Change Notice No.	Notification date	Implementation date
CN/A/23/004	September 18, 2023	December 18, 2023

**Subject:** Change in height of mdi 8" TC port used in mdi Single Use Assemblies.

**Old Design**

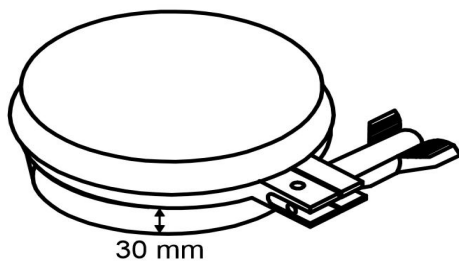
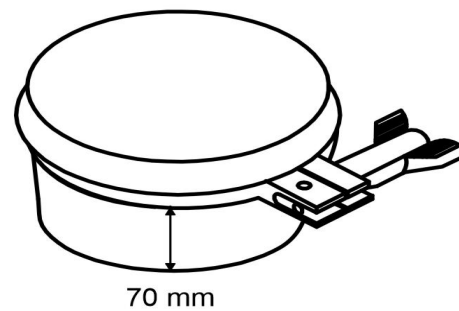
The existing design of 8" TC port in 3D bag is not user friendly, as the space between port and bag is not enough for free movement of the screw on TC clamp, during the clamping process.

In order to make the clamping process convenient and user friendly, the height of the TC port has been increased.

The change will make the clamping process of 8" TC port convenient and user friendly.

From a user point of view, the change in height of the port will make it use friendly and it will not affect the other properties e.g fitment, dimension of the product under actual conditions of use. The change also does not affect the quality of the product. All performance specifications, product attributes and material of construction will remains the same.
